<b>Application No.</b>	<b>Proposed Use(s) / Development(s)</b>	<b>Date of Consideration</b>	<b>Approval Conditions</b>
1.	A/NE-KTS/460	Proposed Houses	21.12.2018	(a), (b), (c), (d) and (g)
2.	A/NE-KTS/466	Proposed Residential Development and Minor Relaxation of Plot Ratio and Building Height Restrictions	13.12.2019	(a) to (f)
3.	A/NE-KTS/528	Proposed House Development	9.6.2023	(a), (b), (c), (d) and (g)
4.	A/NE-KTS/525	Proposed Residential Development and Minor Relaxation of Plot Ratio Restrictions	27.10.2023	(b) and (c)

**APPLICATION FOR PERMISSION  
UNDER SECTION 16 OF  
THE TOWN PLANNING ORDINANCE  
(CAP. 131)**

**Proposed ‘House (not elsewhere specified)’ Development and Proposed Minor Relaxation of Maximum Plot Ratio Restriction in “Residential (Group D)” Zone at Lots Nos. 407 S.A ss.2 S.A and 408 S.B ss.1 RP in D.D. 94, Hang Tau Tai Po, Kwu Tung South, New Territories (S.16 Planning Application TPB Ref: A/NE-KTS/538)**

Figure 5c - Master Layout Plan

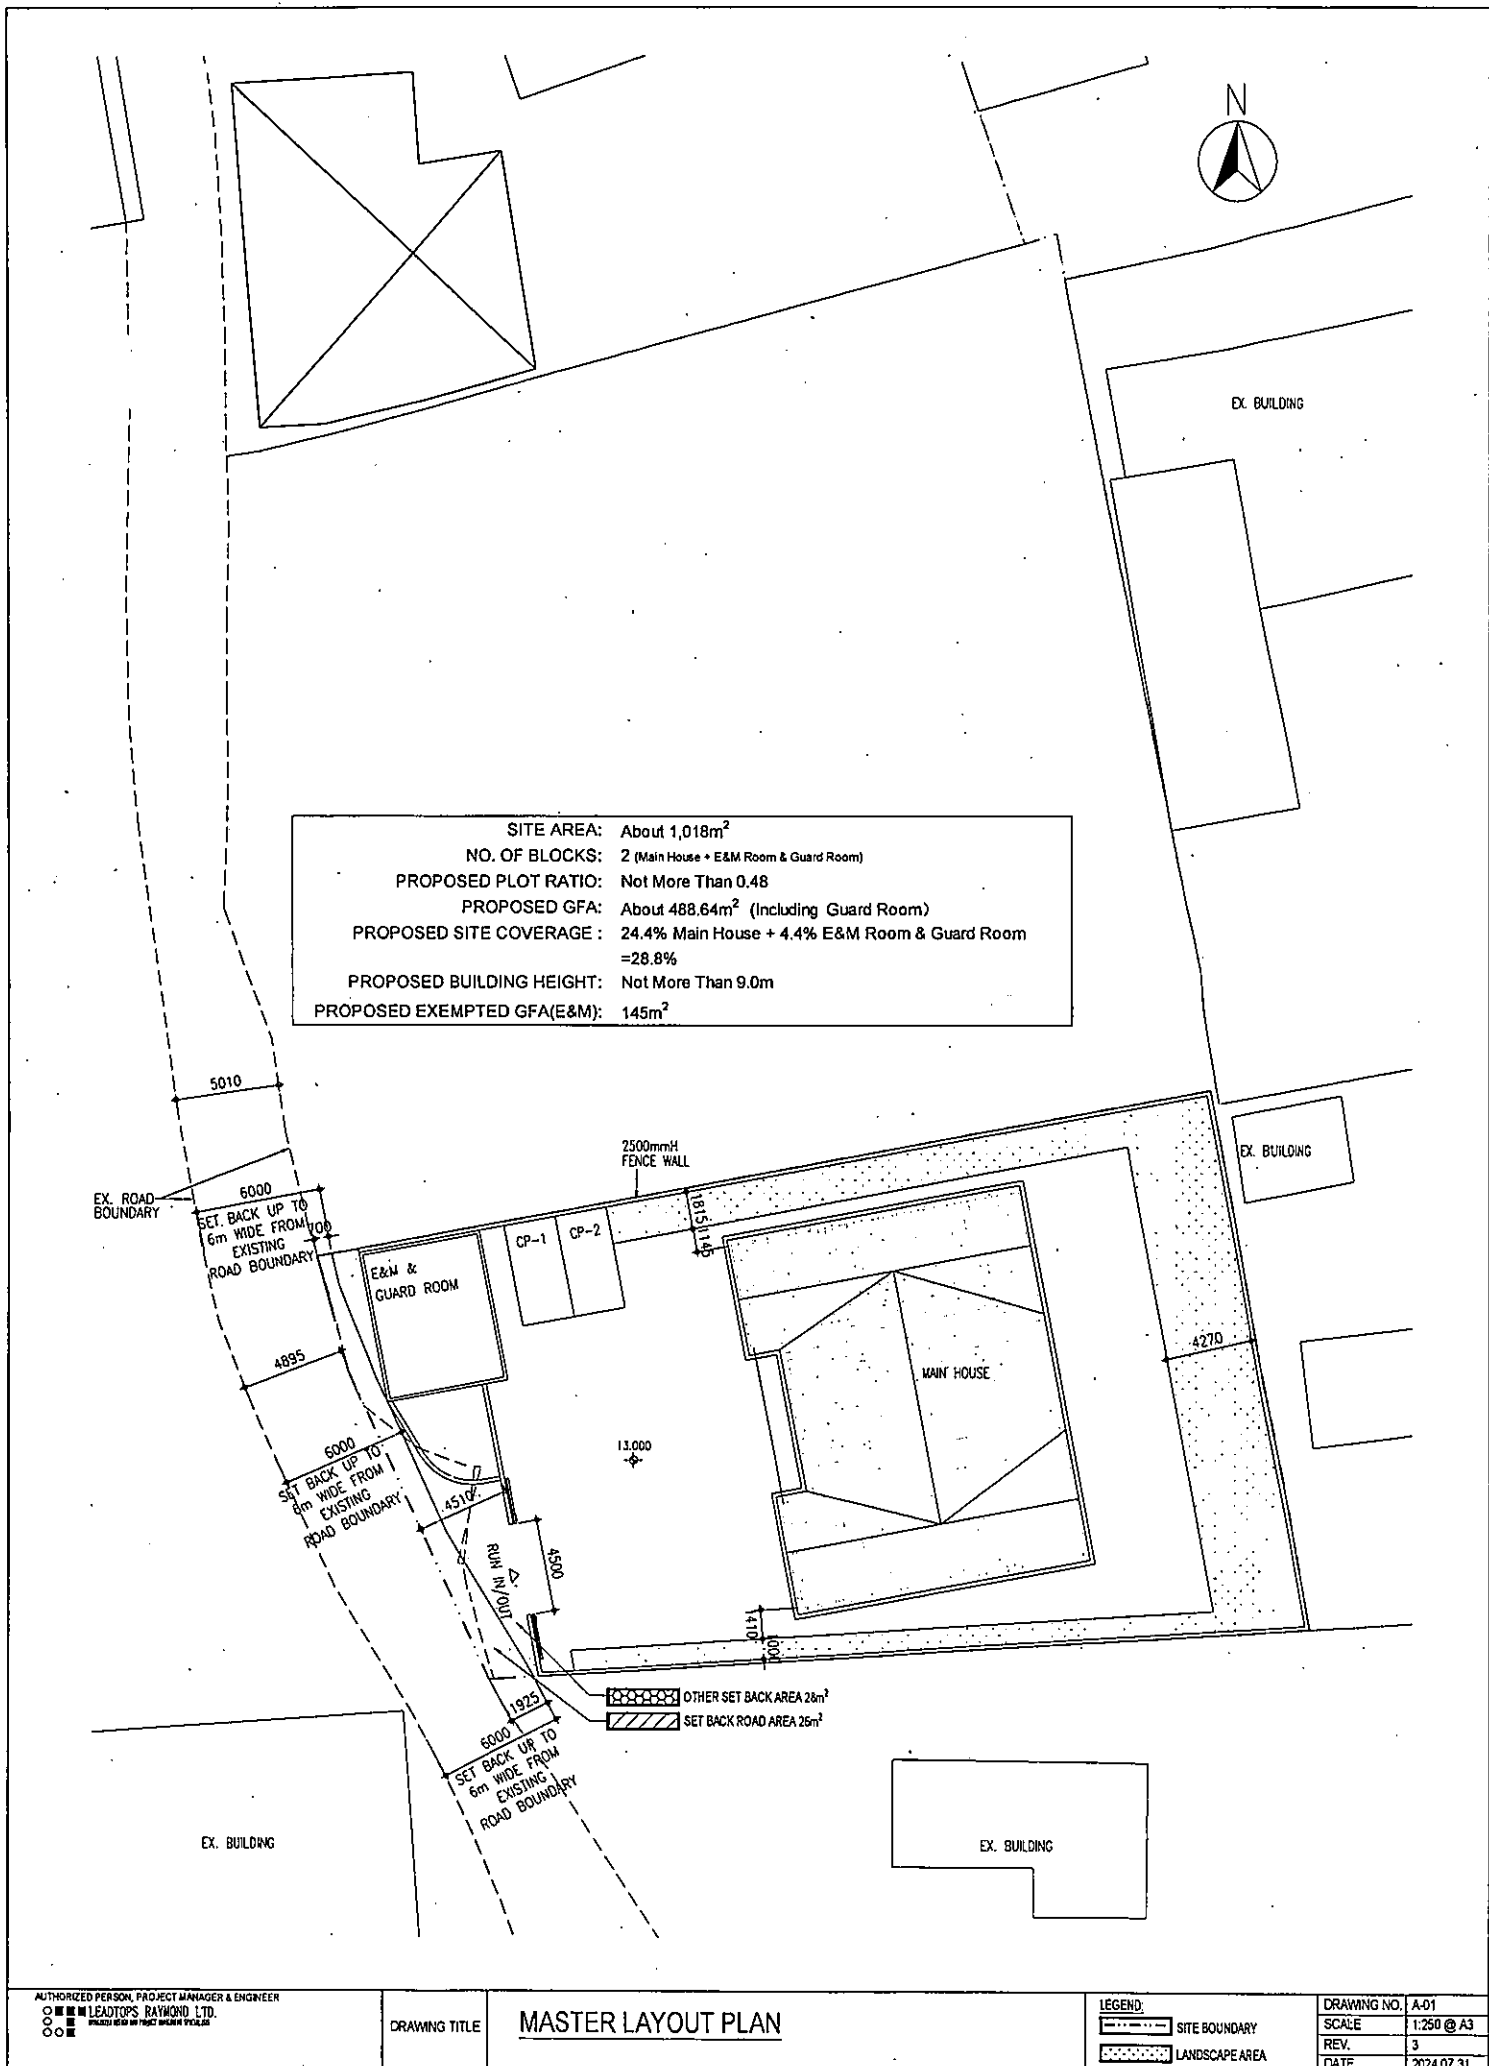
Departmental Comments		Applicant's Responses
<b>A. Comments from the Chief Buildings Surveyor/New Territories West, Buildings Department received on 29 July 2024</b>		
1.	Based on the information provided, in particular of the height, the underground E&M facilities and water tanks may be considered as a storey under the Buildings Ordinance.	<p>In response to BD's specific concerns, the AP of the Project Team is now proposed to relocate the underground E&amp;M utilities to the west of the main house with a 1m separation from the main house footprint. The underground facilities will be accessible from outside the building.</p> <p>As such, a set of revised plans, i.e. <b>Figures 5c, 6d, 7c, 11d and 12a</b>, is now attached in <b>Annex A</b> to replace the original ones.</p>
